REQUEST FOR TENDER RFT #B24-02

Washroom Upgrades

ADDENDUM NO. 2

4.2 Queen Victoria Public School

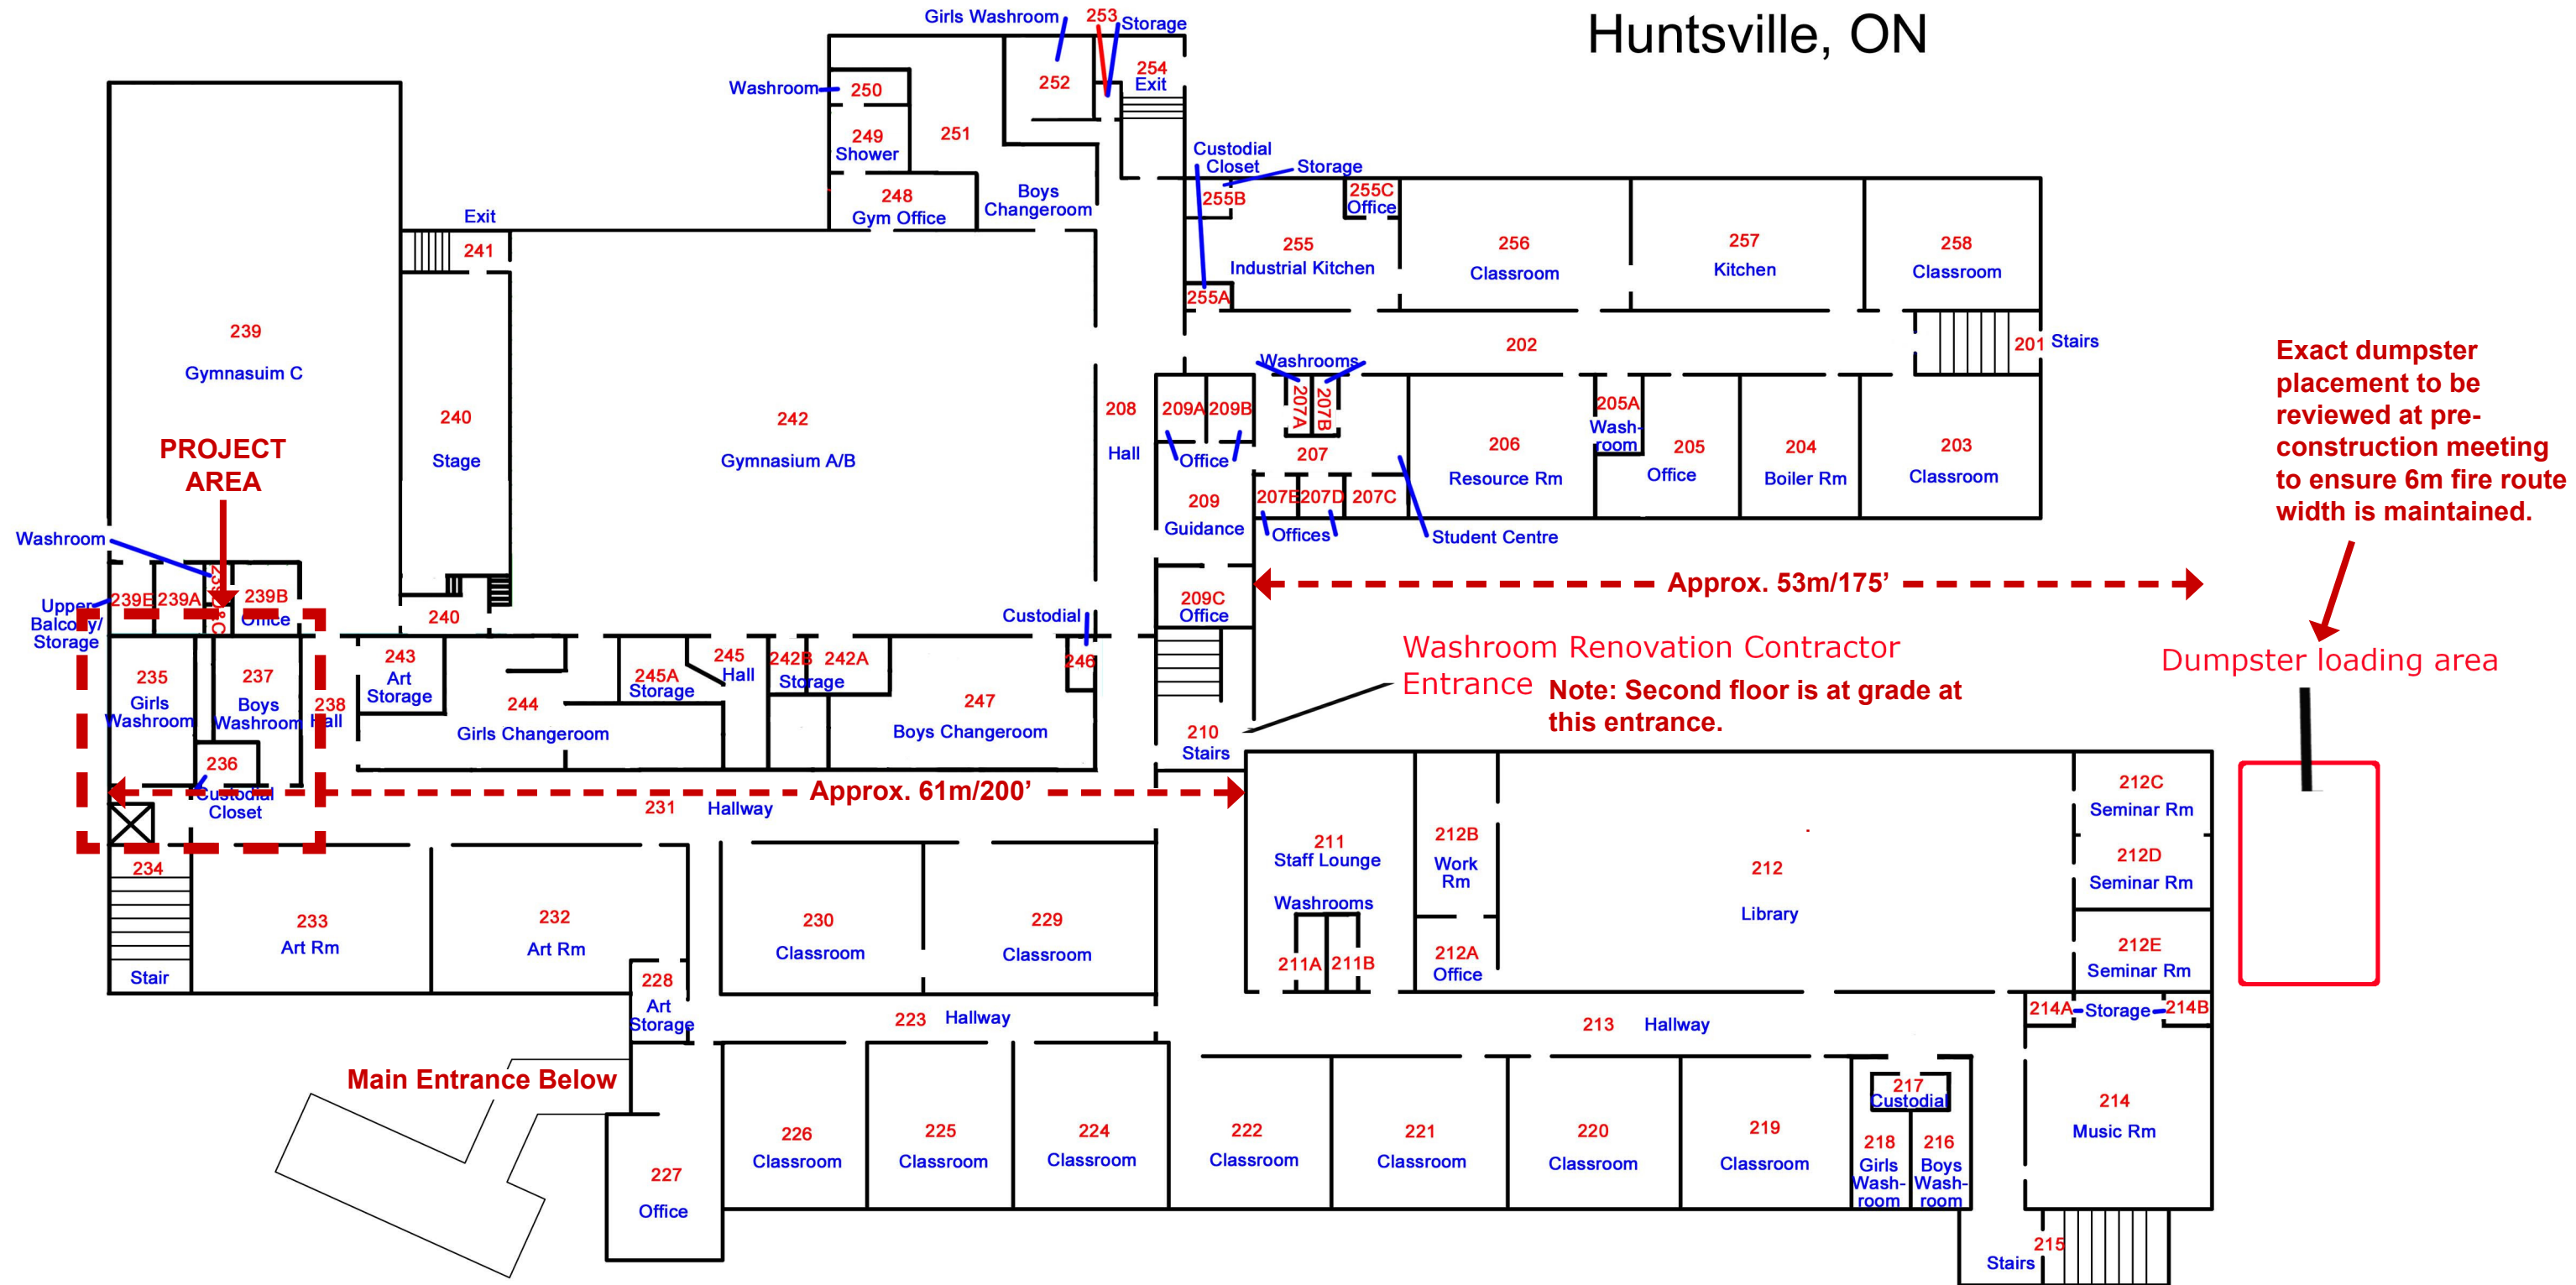
- .1 **Lead abatement.** Lead abatement at this project location has been completed by TLDSB. Refer to Addendum #3 to follow for clarification of the now modified substrate and any additional measures required affecting tile application as a result of the abatement.
- .2 **Water supply pipe length.** Refer to attached Addendum #2 Diagram 4.2.2 for clarification of the horizontal length for the new 65mm DCW supply piping.

HUNTSVILLE HIGH SCHOOL RFT B24-02 ADDENDUM #2 ACCESS ROUTE SITE PLAN 3.6C

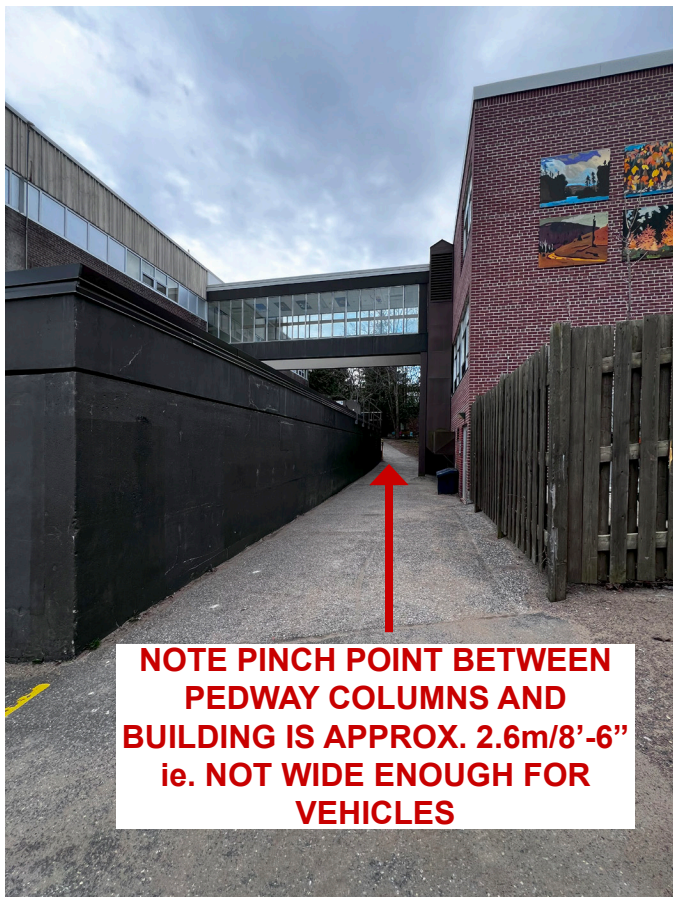
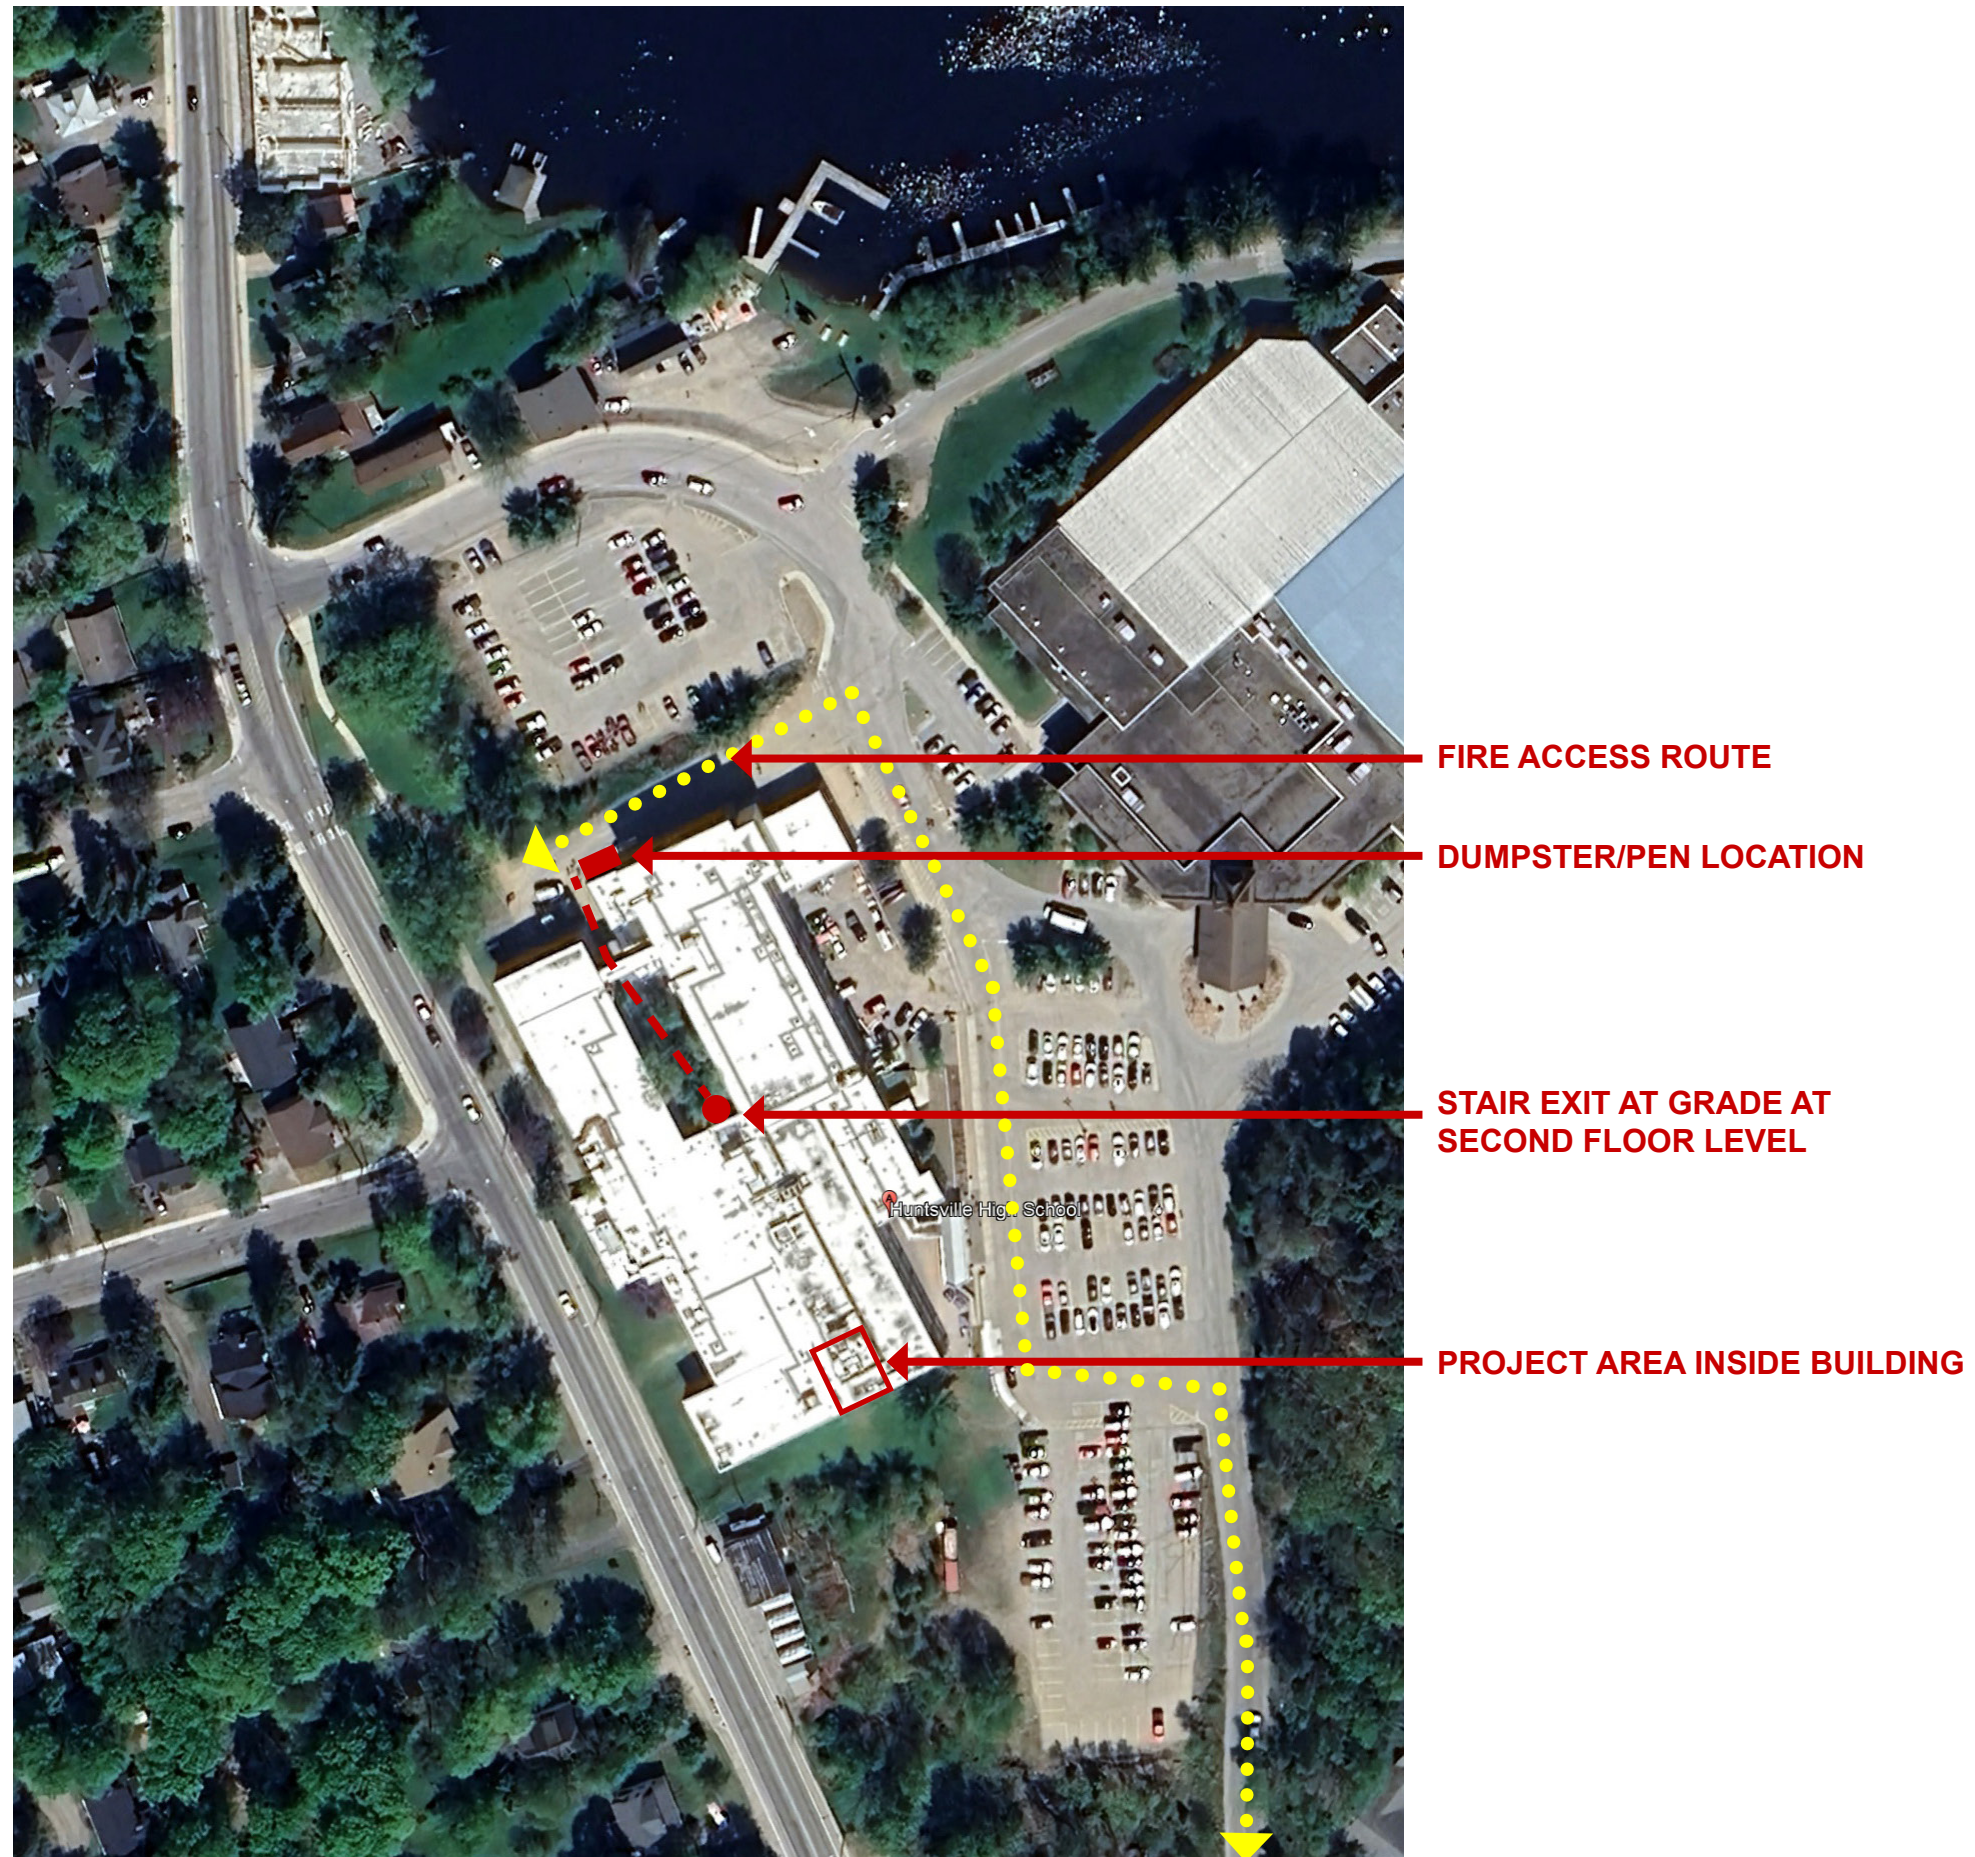
Instead, refer to the attached *Addendum #2 Diagram 3.6A, Access Route Photos 3.6B and Access Route Site Plan 3.6C* for the access route for the RFT B24-02 washroom project and the following clarifications relating to the access route. The bidder is to include the following in their bid price:

BIDDER TO INCLUDE TEMPORARY PROTECTION FOR EXISTING GAS PIPING AND STEEL COLUMNS SUPPORTING PEDWAY FOR DURATION OF THE PROJECT.

PROPOSED DUMPSTER LOCATION - TO BE REVIEWED AT PRE-CONSTRUCTION MEETING

NOTE PINCH POINT BETWEEN PEDWAY COLUMNS AND BUILDING IS APPROX. 2.6m/8'-6" ie. NOT WIDE ENOUGH FOR VEHICLES

1. **Floor protection.** The floor within the building along the entire length of the access route(s) is to be protected for the duration of the project with "Ramboard" a minimum of 1.8m/6' wide and the full length of the hallways. Refer to diagram 3.6A for approximate hallway lengths. Floor protection to be maintained for the duration of the project and damaged or worn sections of floor protection are to be repaired as needed. All seams to be taped.

2. **Stair well protection.** Treads, risers and landings are to be protected with 19mm/3/4" plywood full width of stair (approximately 1.8m/6') and entire surface of landings – allow for two landings approximately 2.4m x 4.6m (11m2/120 sq.ft.) and one landing 3.3m x 4.6m (15.2m2/160 sq.ft.).

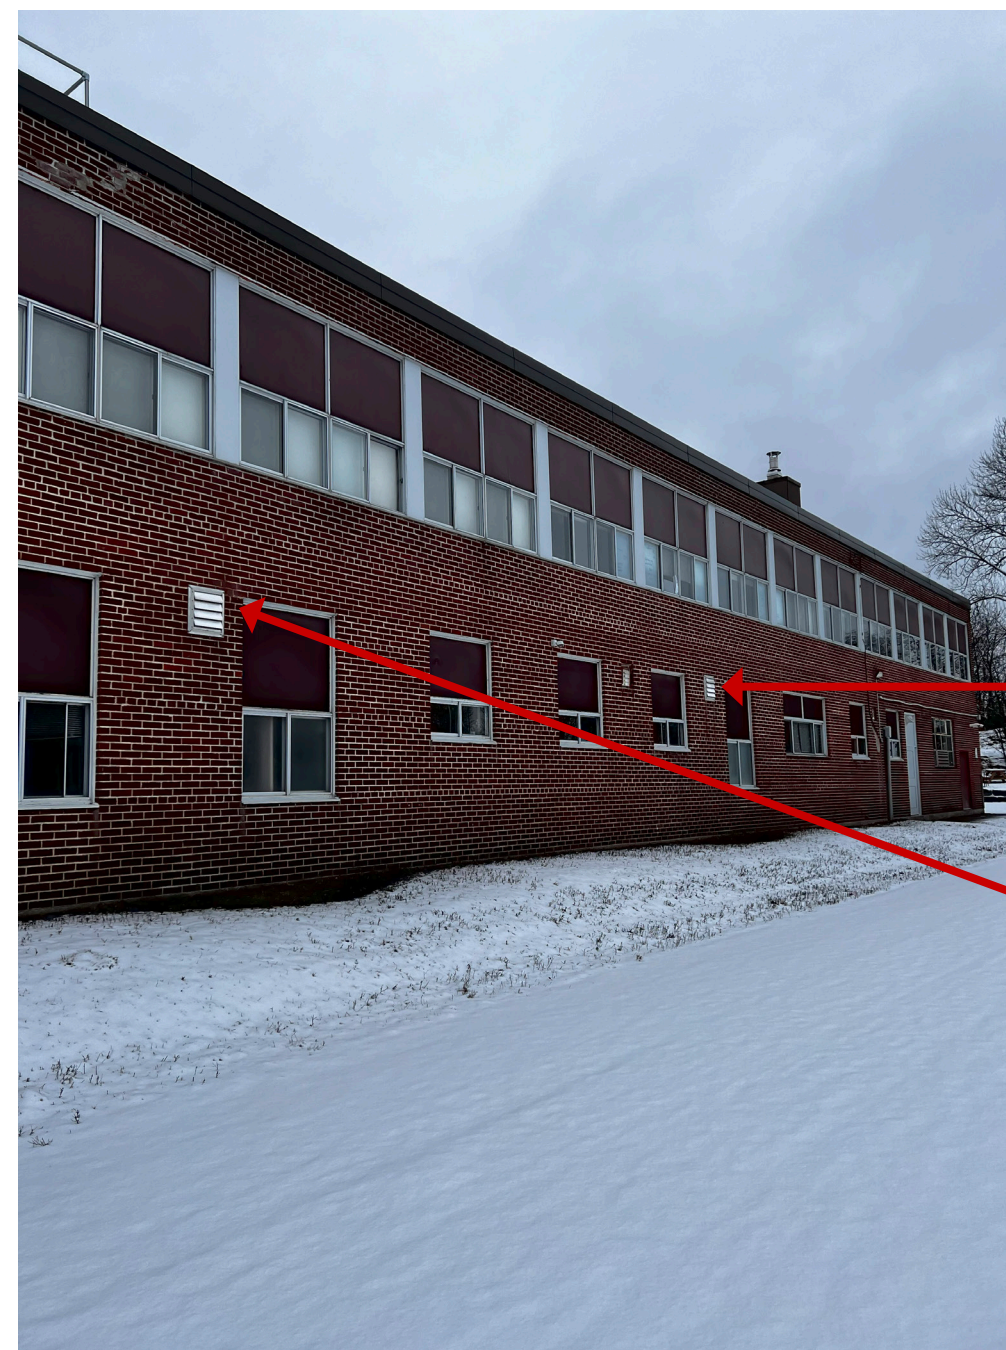
- .4 **Exterior exhaust/Barn fan removal.**
 - a. Bidders are to include for boom lift or other appropriate scaffolding/lift equipment to remove the existing “barn exhaust fans” and louvres currently exhausting the bathrooms on the main and second floor and as indicated in the mechanical drawings for removal which will need to be accessed from the exterior. See photos attached on sheet 4.1.4.

- b. Bidders are to include masonry, flashing, insulation, and sealant work required to modify the existing barn fan openings to suit the new louvres and a weathertight installation.
